Development Applications

DA Number	DA 2025 / 00100
Applicant	R Hookway
Proposal	Food Services – Legalisation of Shed with Amenities & Roofed Walkway & Additional Verandah to Heritage Listed Homestead
Location	“Glencoe” 22464 Tasman Highway, Falmouth (CT 168326/1 & CT 141662/1)

From: [Lynden Jones](mailto:lyndenjonesarchitect@gmail.com)
Sent on: Monday, 10 November 2025 6:10:28 PM
To: [Chris Bonner](#); [Break O Day Office Admin](#)
CC: [Deb Szekely](#)
Subject: 'Glencoe', 22464 Tasman Highway, Falmouth - RFI
Attachments: Glencoe Estate-Homestead- Verandah Details.pdf (130.48 KB)

From: [Lynden Jones](#)
Sent on: Wednesday, 16 July 2025 2:24:37 PM
To: [Break O Day Office Admin](#)
CC: [Deb Szekely](#)
Subject: Re: 22464 Tasman Highway, Falmouth - DA 100-2025
Attachments: DA-APPLICATION-Glencoe.pdf (896.38 KB), 25 13062 Request for Further Information Invalid - DA 100-2025(4).pdf (357.31 KB), RFI Attachment - Flood Prone Areas.PDF (1.93 MB), Development Application Form - DA 100-2025.PDF (723.58 KB), Planning Invoice - DA 100-2025 - Additional (Advertising).pdf (223.11 KB)

Job No. 250101	Drawing No. A00-02	<u>drawing</u> Site Plan	Rev. A	date 6/6/2025	notes Issued For DA revision	general notes Notes
	date	<u>project</u> Amenities Building Walkway				
	scale @ a3 1:500	<u>client</u> Russel & Jane Hookway				
	drawn by LJ

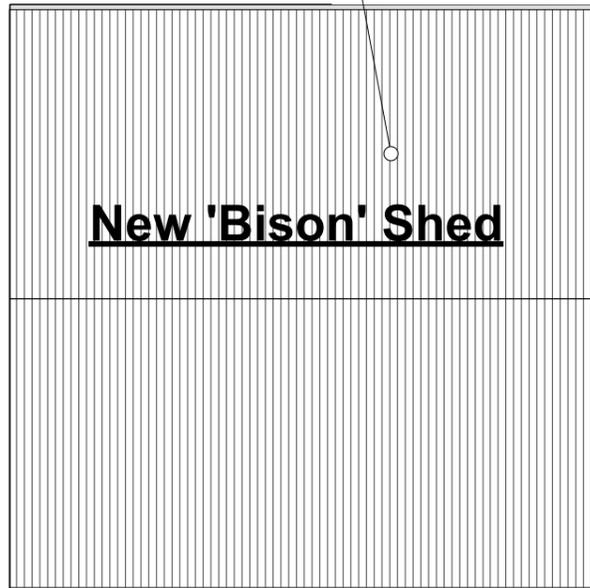
The site is affected by Council's Flood Prone Areas mapping (attached). Please provide confirmation by way of an amended site plan that demonstrates the development is not within the mapped flood prone areas. Similarly, please provide confirmation that the development is not within the Waterway and Coastal Protection Overlay to the west.

Response: The New Shed & Walkway and homestead area a substantial distance form any Flood Prone Areas the existing homestead is very visible on the map and is the new shed and walkway are even further form any flood prone areas shown on the map.
